ADDENDUM NO. 1

Date: August 11, 2023
Project Name: Runway 18L-36R Pavement Reconstruction
Owner: Denton Enterprise Airport
TxDOT CSJ No.: 2318DENTN
Garver Project No. 23A11280

LIGHTING REMOVAL
PLAN 6

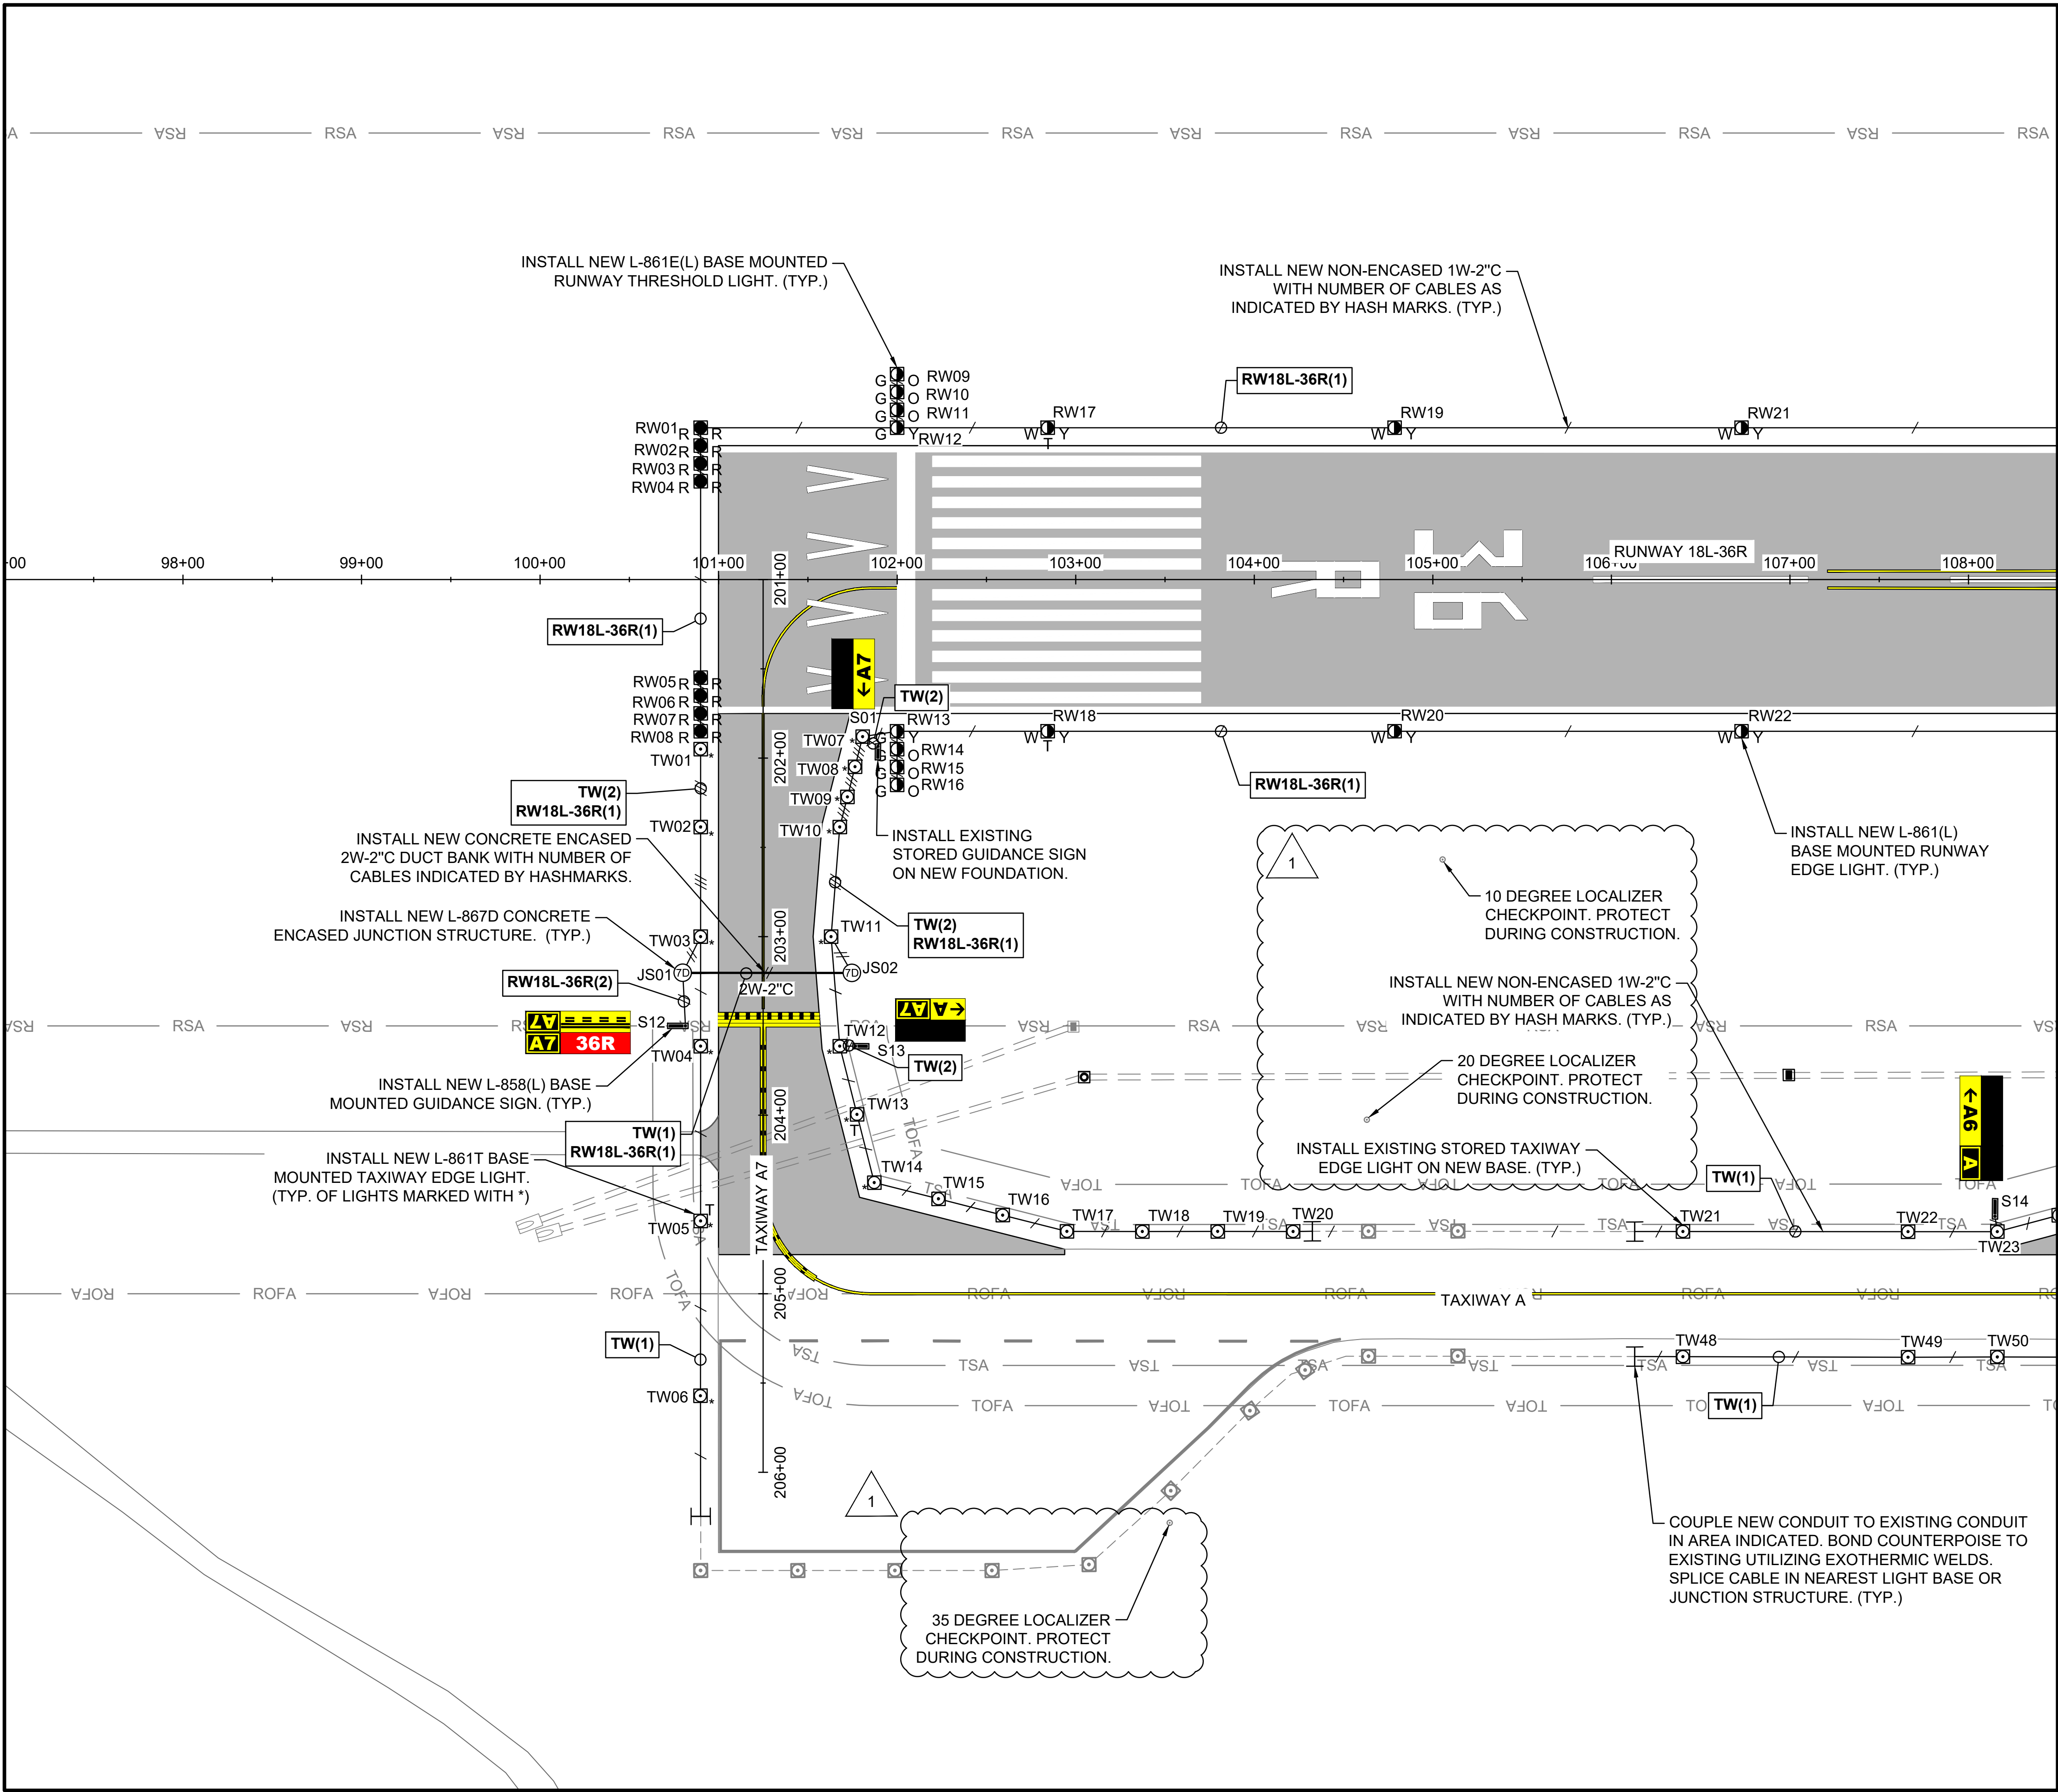
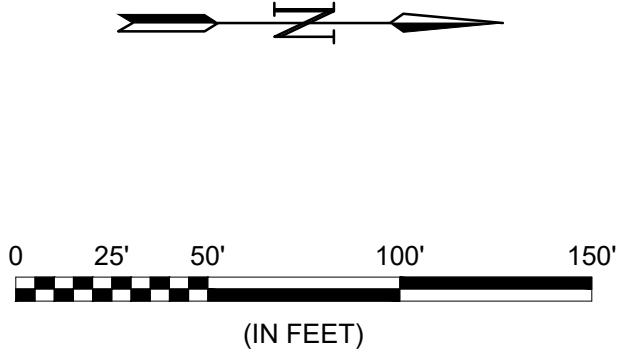
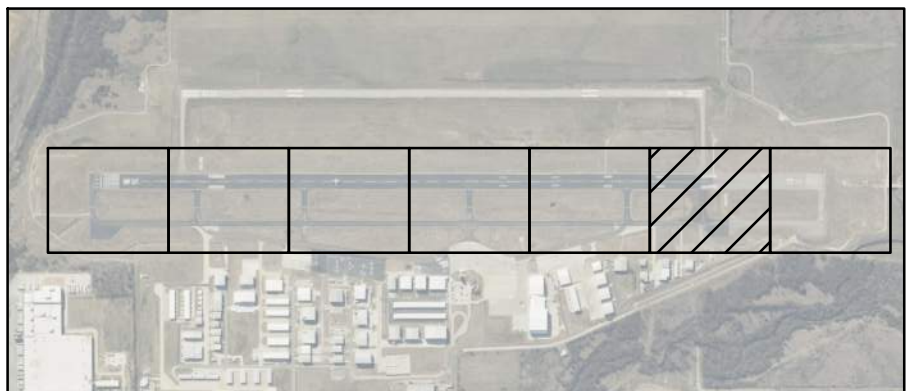
11. Updated Lighting Removal Plan, updating conduit removal detail, and the PAPI removal. Sheet "ED-106 Lighting Removal Plan 6"
12. Updated Lighting Installation Plan 1, updated Localizer Checkpoint Locations. Sheet "EL-101 Lighting Installation Plan 1"

EL-103

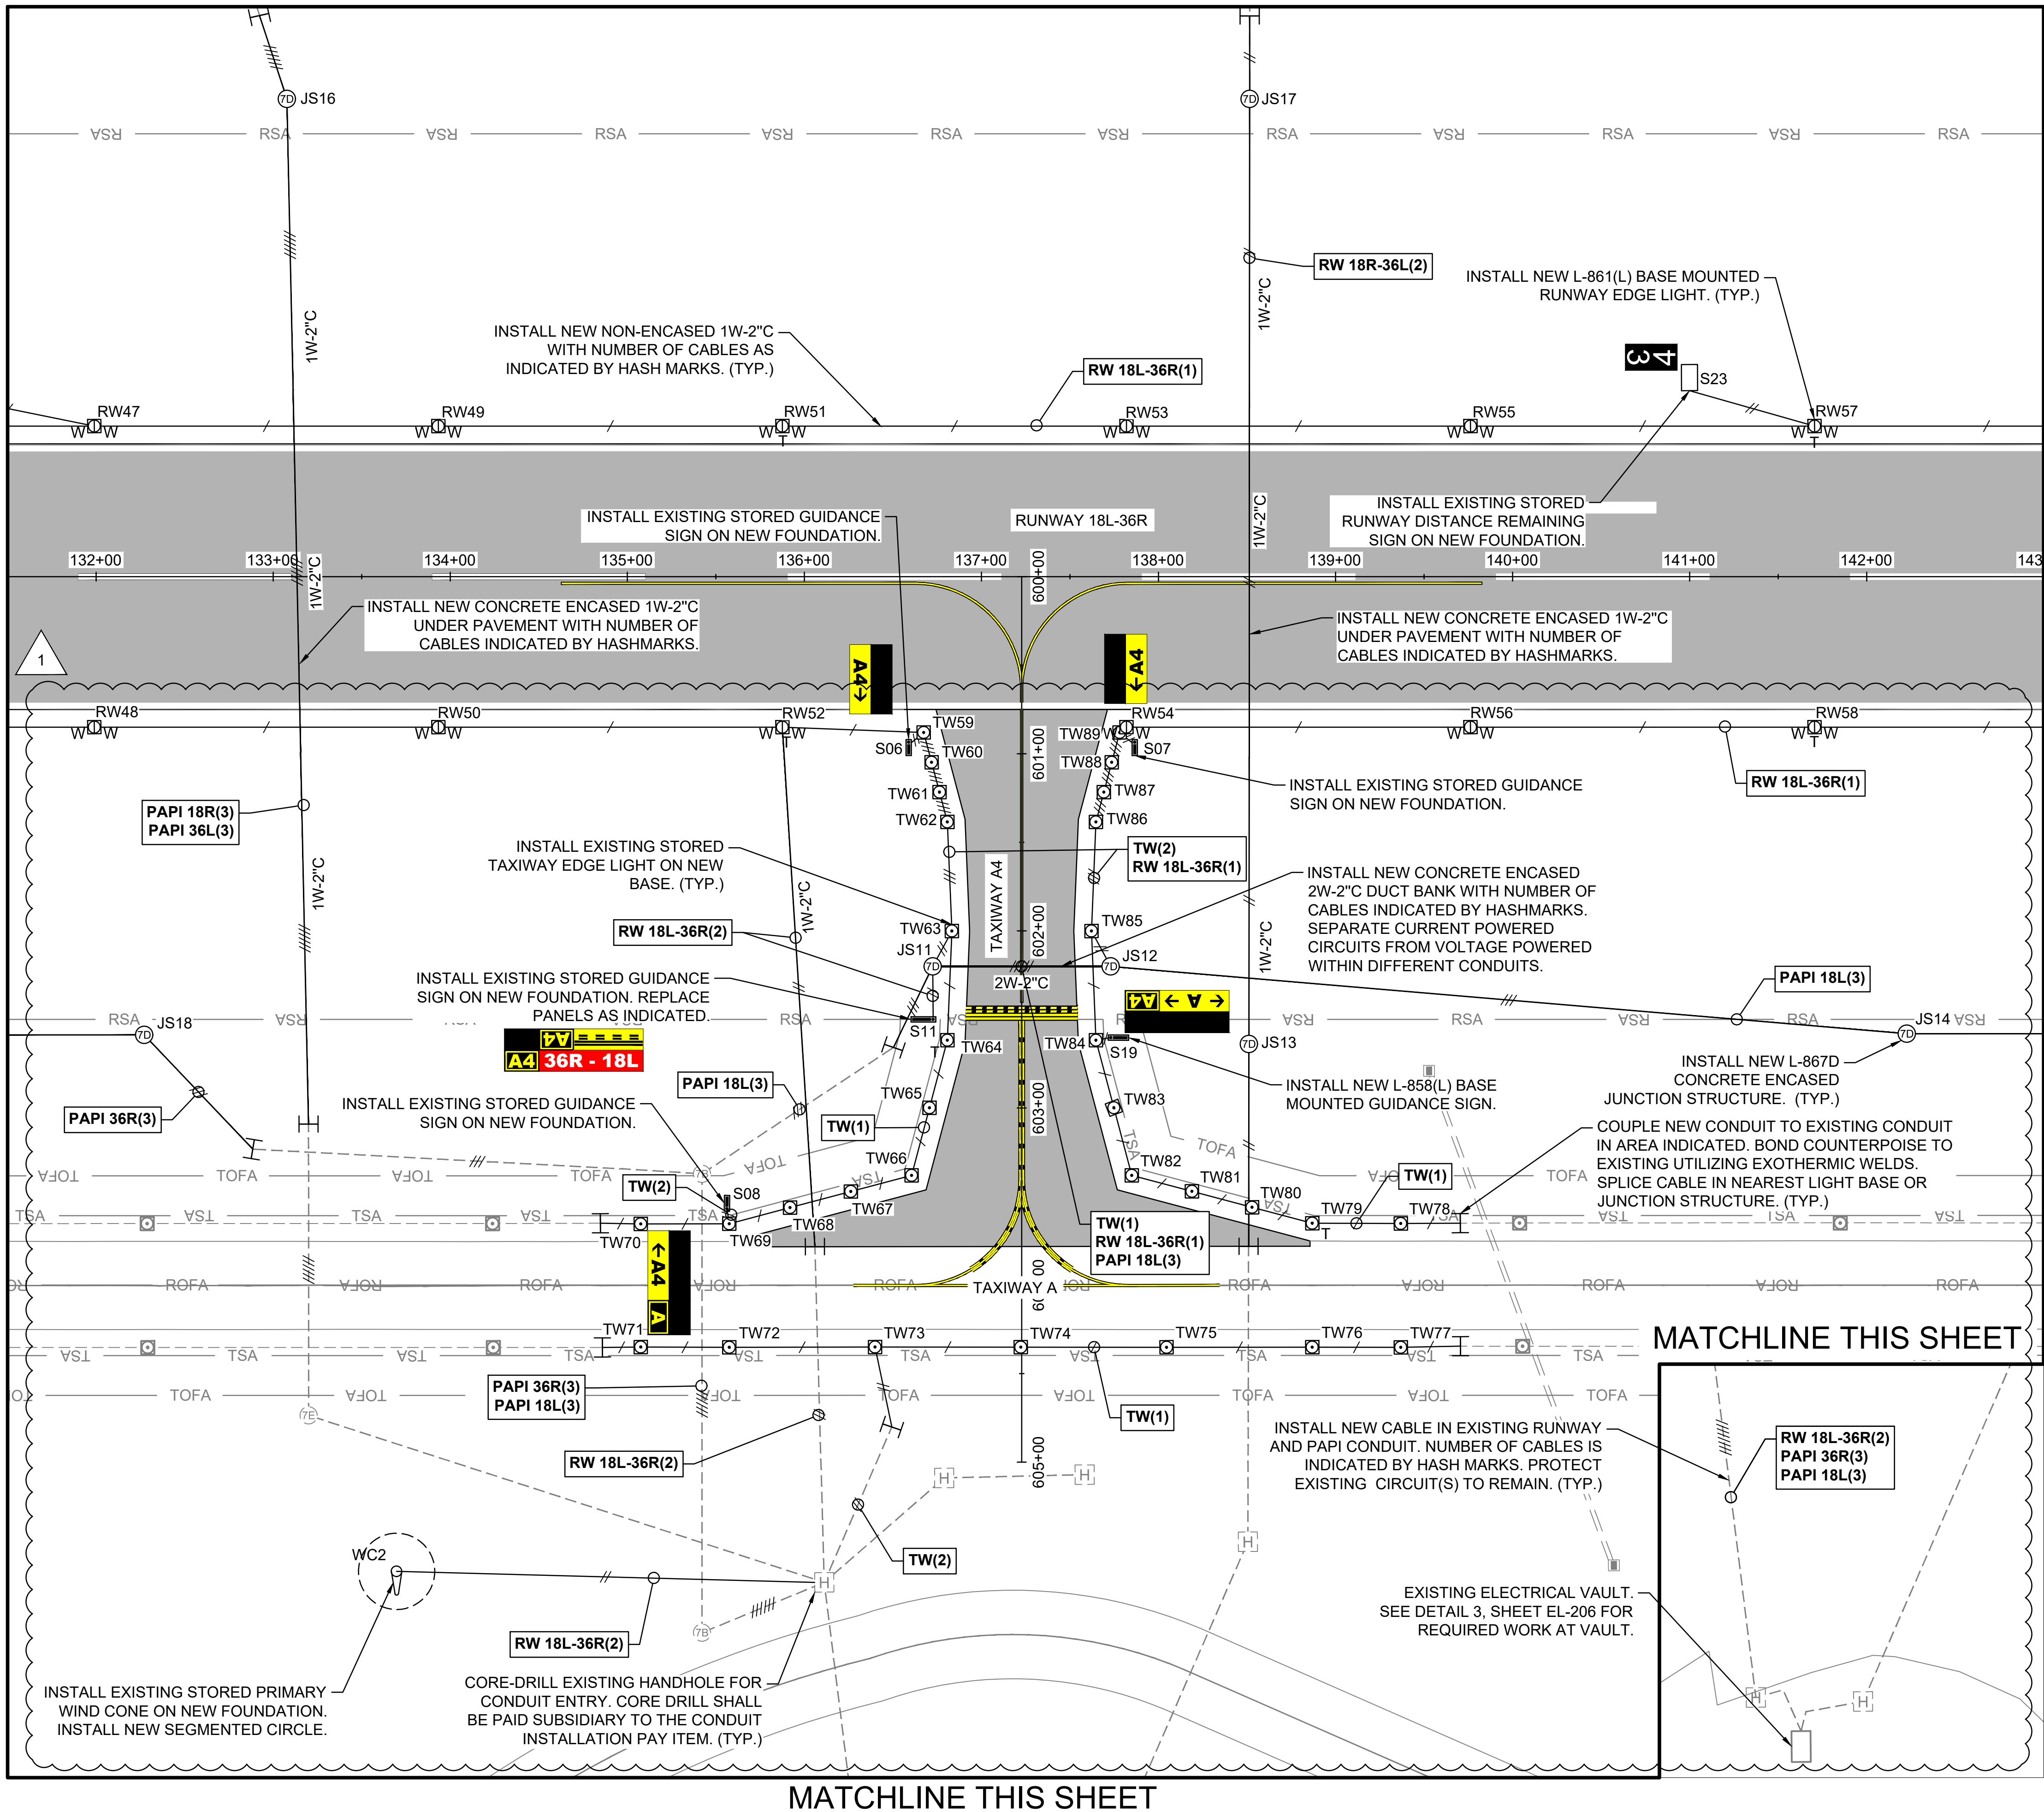
13. Updated Lighting Installation Plan 2, updated to include PAPI replacement. Sheet "EL-102 Lighting Installation Plan 2"
14. Updated Lighting Installation Plan 3, updated to include PAPI replacement. Sheet "EL-103 Lighting Installation Plan 3"
